**DOCKET****09-AAER-2**DATE May 27 2011RECD. May 27 2011

Subject: 2010 Rulemaking Proceeding Phase II on Appliance Efficiency Regulations
(Docket # 09-AAER-2)

Figure 1 Efficiency of NiMH battery charge cycle
 Discharge 2A to 6V
 Capacity 2302mAh

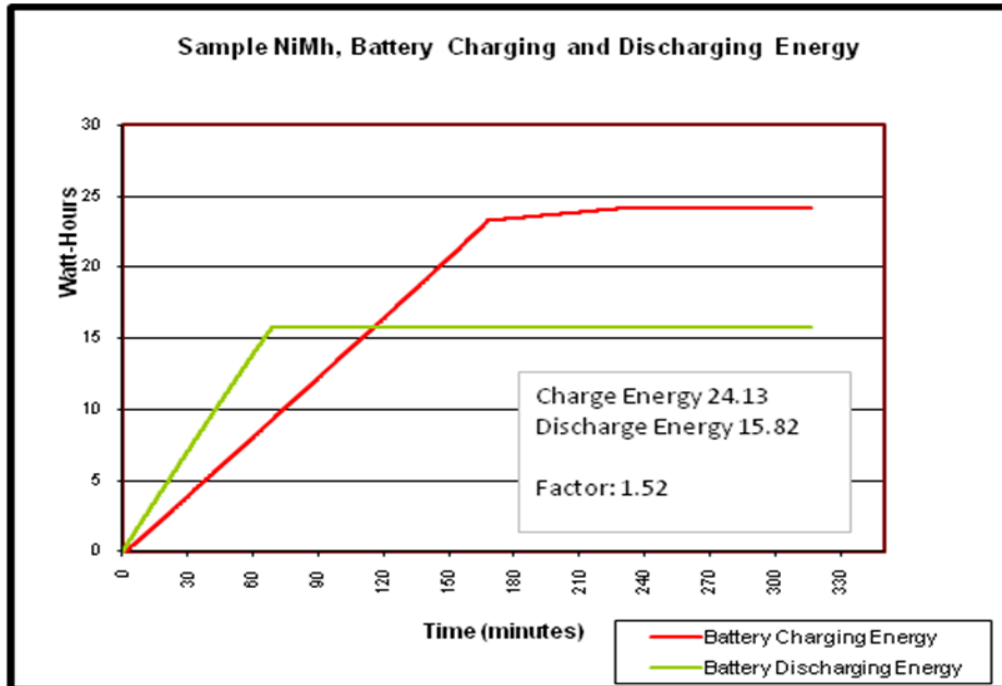
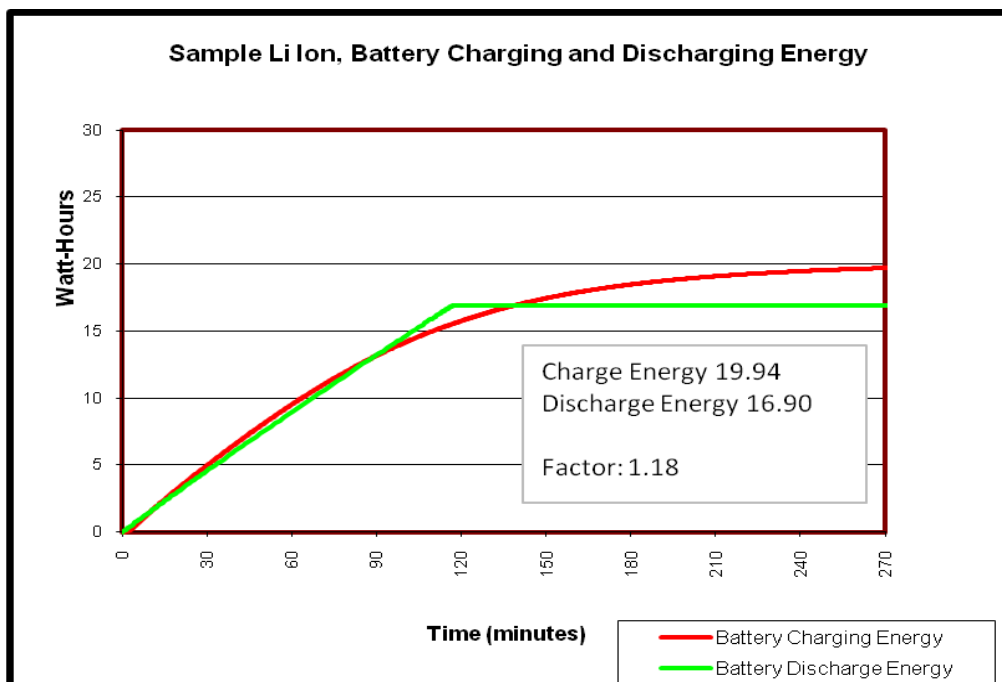
In the response to comment 15, the CEC draft Staff Report states “It is feasible to meet the proposed regulations with any battery chemistry.” As noted in the Black and Decker presentation at the recent CEC workshop on May 19, 2011, this is not true for all battery chemistries at higher energy levels. And while this may be technically true for the lower energy batteries typically found in simple consumer products with long battery charge cycles, it is not the case for battery charging systems for non-consumer products with higher energy batteries, advanced functions, and rapid charge cycles. Of particular concern are the nickel-based batteries that are heavily used in mission-critical applications where superior performance across all temperatures is required. While nickel-based batteries have the aforementioned advantages, they also have shortcomings. Nickel batteries naturally have higher loss during recharge. Note figures 1 and 2 below which show the difference in charging efficiency between a typical NiMH battery used by MSI and a typical Lithium Ion battery used by MSI.

Not accounting for this fundamental difference in the efficiency requirements places significant additional burden on the charging solution for Nickel chemistry batteries. Excluding for a moment consideration of the No Battery and Maintenance Mode requirements:

As demonstrated by the graphs and calculations above, given the lower charging efficiency of NiMH batteries, the battery charging system for these batteries must be 95% efficient in order to meet the proposed requirements, whereas the battery charging system for the more efficient Lilon battery only needs to be 74% efficient.

If we agree that the Lilon system, with a charge factor of 1.18, is representative of the technology, then the margin of $(1.6-1.18)=0.42$ in the current proposed regulation would seem to be acceptable. A similar margin allowed to chargers of nickel-based batteries would yield a charge factor of $(1.52+0.42)=1.94$. Therefore, Motorola Solutions, Inc. proposes the use of $(12+1.9\text{Eb})\times\text{N}$ as the limit on 24-hour charge and maintenance energy for nickel-based batteries.

In its current form, the CEC proposal, instead of being neutral, is far more restrictive of nickel batteries. This will require these types of chargers to undergo more extensive design changes which will result in much higher costs and cycle times to get compliant designs to the market (if compliance is even achievable). This would mean increased selling prices to mission critical customers, and could result in product unavailability or shortages. It would be far more appropriate to differentiate the proposed energy efficiency requirements based on battery chemistry, or alternatively to raise the proposed limits for each mode across the board.
